ALERT SERVICE BULLETIN

NO. 407-10-93

MODEL AFFECTED: 407

SUBJECT: TAILBOOM ATTACHMENT HARDWARE,
REPLACEMENT OF.

FIGURE 1: Replacement of tailboom upper attachment bolts (Sheet 1 of 2)

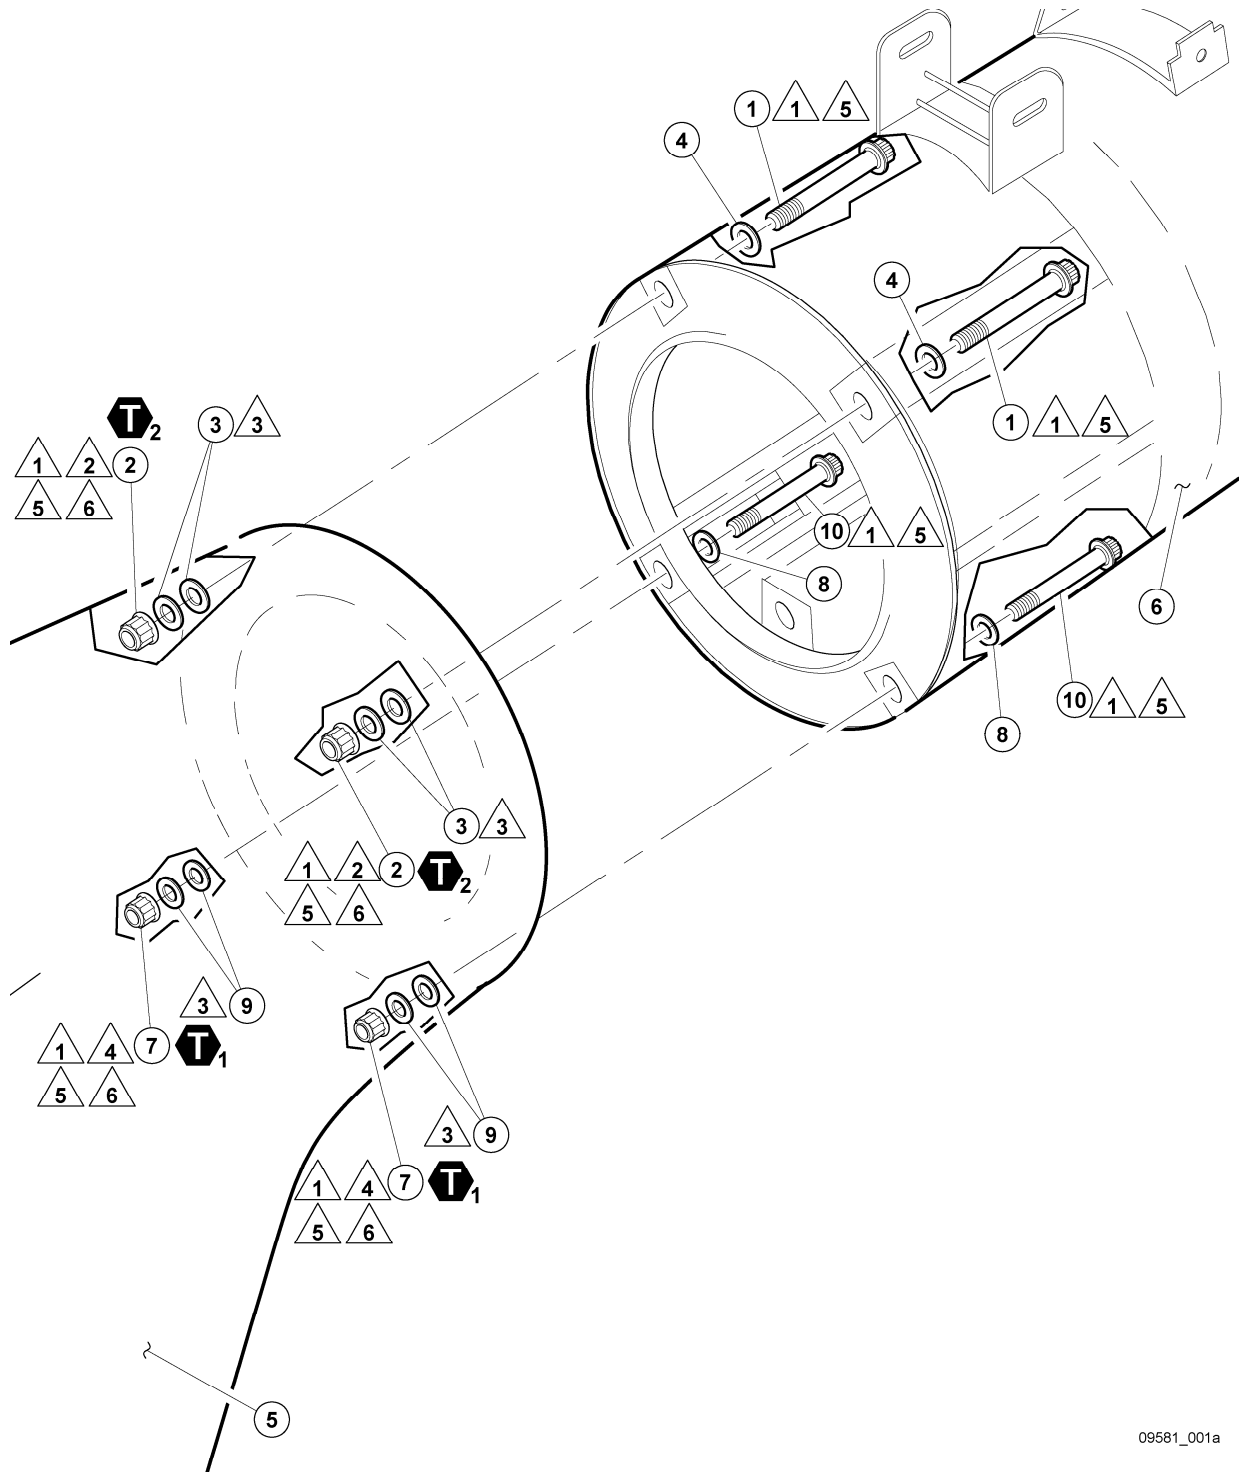
Bell Helicopter has reviewed the tailboom attachment installation of the Model 407. It has been determined that the torque values specified in the maintenance manual and used during assembly of the 407 for the tailboom attachment bolts exceed the specified torque range recommended for subject bolts.

This bulletin mandates the removal of the existent tailboom attachment hardware and the installation of new hardware with reduced torque values. In addition, specific hardware installation/torquing procedure is provided for the tailboom to aft fuselage joint.

1. (Ref. Figure 1) Remove left upper attachment bolt (1) and nut (2) but retain the chamfered washer (4) and the regular washers (3). Discard the nut (2) and the bolt (1) you have removed.

5. (Ref. Figure 1) Remove left lower attachment bolt (10) and nut (7) but retain the chamfered washers (8) and the regular washers (9). Discard the nut (7) and the bolt (10) you have removed.

- b) Run the nut (7) on the threads of the mating bolt (10) with a dial indicator type torque wrench and measure existing tare.
 - c) Torque the nut (7) between 360 to 370 inch/lbs (40.6 to 41.8 Nm) of torque plus the tare of the nut, (7) using proper tool.

- d) Back off nut (7) at least a minimum of $\frac{3}{4}$ of a turn before re-applying the same torque between 360 to 370 inch/lbs (40.6 to 41.8 Nm) plus the existing tare of the nut (7).

360 TO 370 INCH/LBS
(40.6 TO 41.8 Nm)

570 TO 580 INCH/LBS
(64.4 TO 65.5 Nm)
